Mapleton City Council Staff Report

Consideration of a Resolution approving the Final Plat for the Pheasant View Plat "B" Subdivision consisting of three lots, and a Project Plan for a 69 bed assisted living center located at approximately 800 S and Highway 89 in the General Commercial (GC-1) zone.

MAPLETON CITY DEVELOPMENT REVIEW COMMITTEE MINUTES

Address the following concerns in revised drawings:
Project: Pheasant View "B" Assisted Living Date: January 29, 2014

PLAT "B"

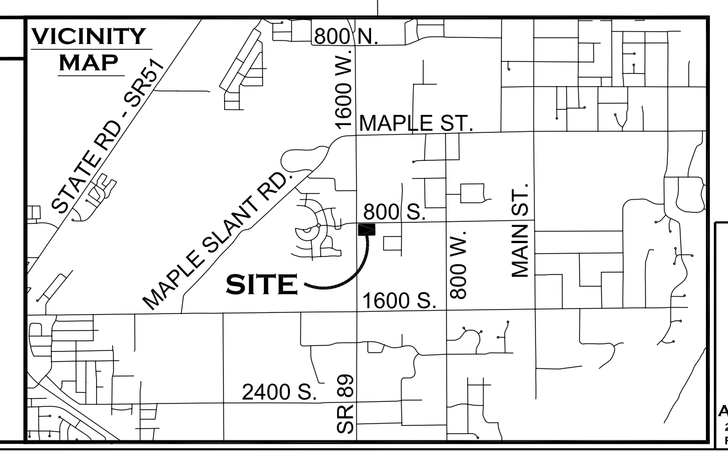
1. Outstanding bonding issues ($55,328.50) will need to be resolved prior to approval of this project. (Items from Dec. 5, 2008 inspection notes and last bond release)
    a. Pheasant View "A" as-builts are required.
    b. Lot # 10 FH needs to be raised.
    c. Lot# 8 replace broken curb, gutter and sidewalk.
    d. Lot#2 replace broken sidewalk.
    e. Lot #28 sidewalk never placed.
2. Page C.1
    a. Note #2 What is the name of the HOA, this HOA should include all 28 lot owners, submit HOA documents that shows this organization.
    b. Note #9 the original developers are responsible to finish the existing basin.
3. Plat "B"
    a. Revise notes #2 and #4.

ABBINGTON SENIOR COMMUNITY @ MAPLETON
WW MANAGEMENT
SITE PLAN

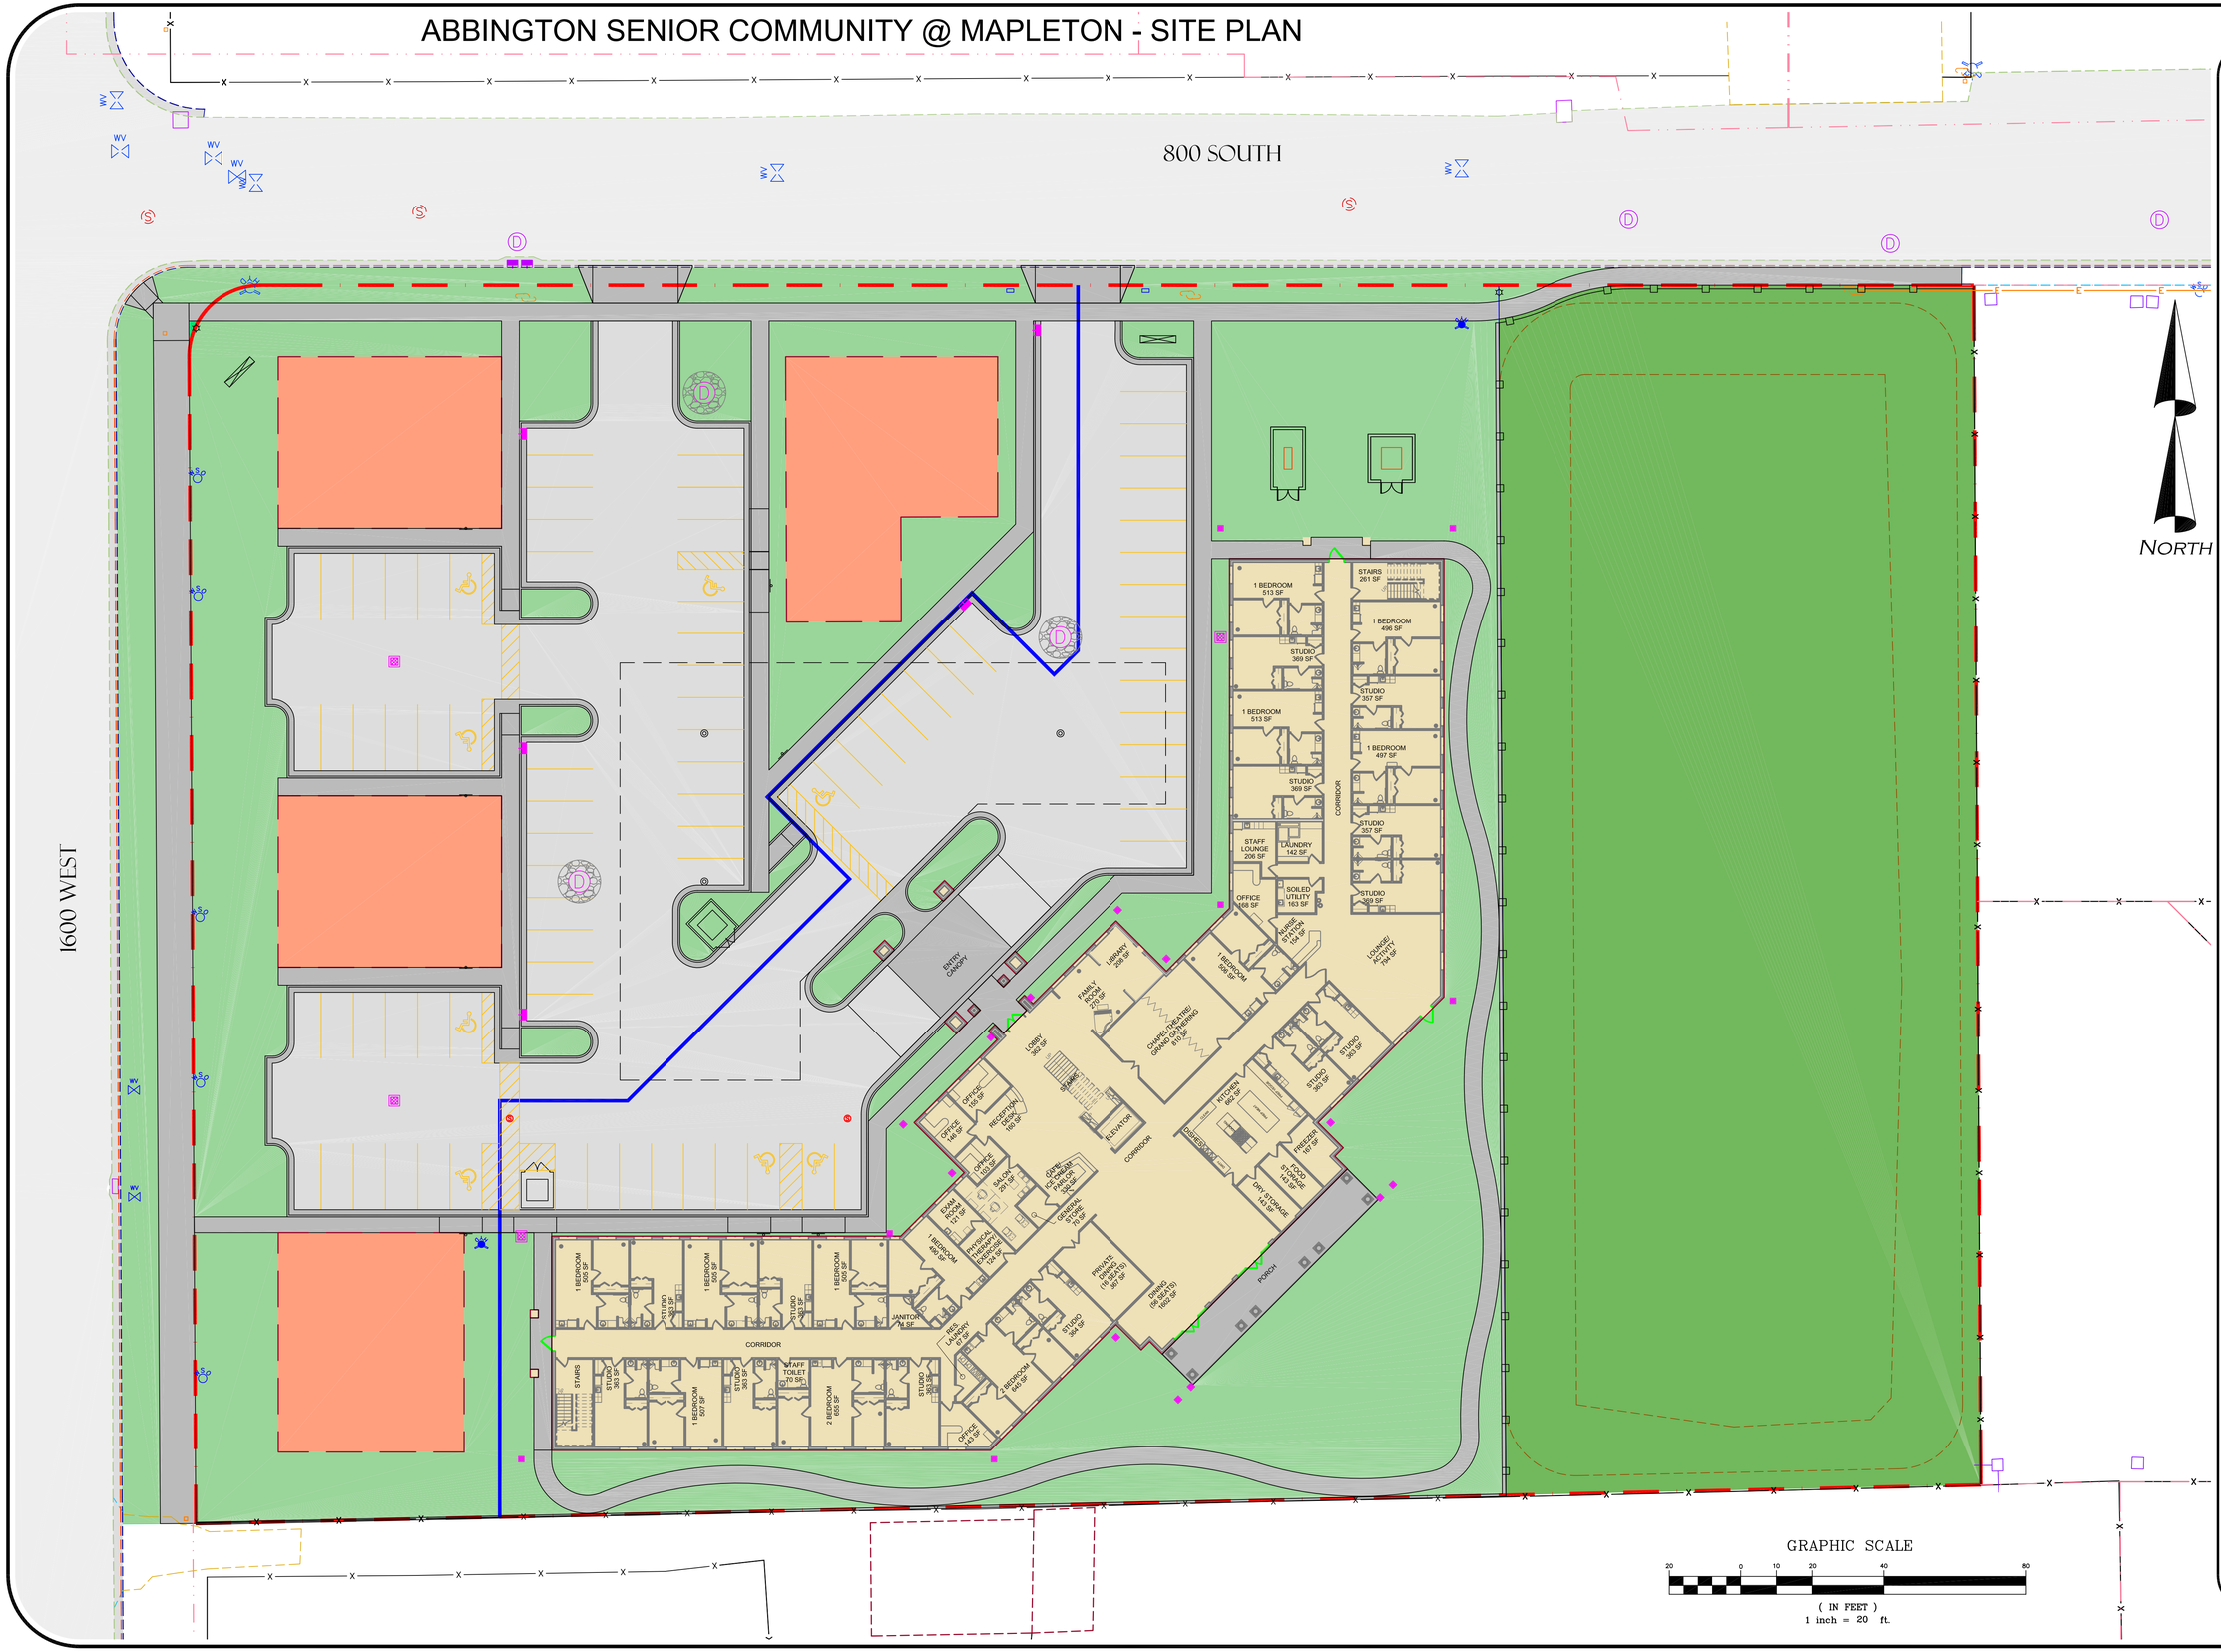
The applicant is proposing a total of 80 spaces that will be shared by the proposed assisted living facility and the future commercial pad sites. With 23 spaces being required for the assisted living facility, 57 spaces will remain for the commercial pad sites. There appears to be sufficient parking to accommodate the pad sites at build-out. However, as the other commercial pad sites develop, the on-site parking may need to be modified based on the proposed uses at these locations.

Response: MCC Chapter 17.15.100 indicates that interior parking lot landscaping areas shall be dispersed throughout the parking lot. Landscaped islands shall be required at the end of the parking rows, and at the midpoint of parking rows which exceed ten (10) parking stalls.

1. The City's landscape ordinance indicates that landscaped islands shall be required at the end of the parking rows, and at the midpoint of parking rows which exceed ten (10) parking stalls, or every ten (10) stalls if parking rows exceed twenty (20) stalls. The code does indicate that these standards may be modified if Commission determines proposed plan achieves better results than adopted standards. Please revise the landscape plan or indicate if you'd like to ask the Commission for an exception. The required revisions will alter your proposed parking configuration and the number of stalls.
2. The project plan requires review by the Planning Commission and final approval from the City Council.
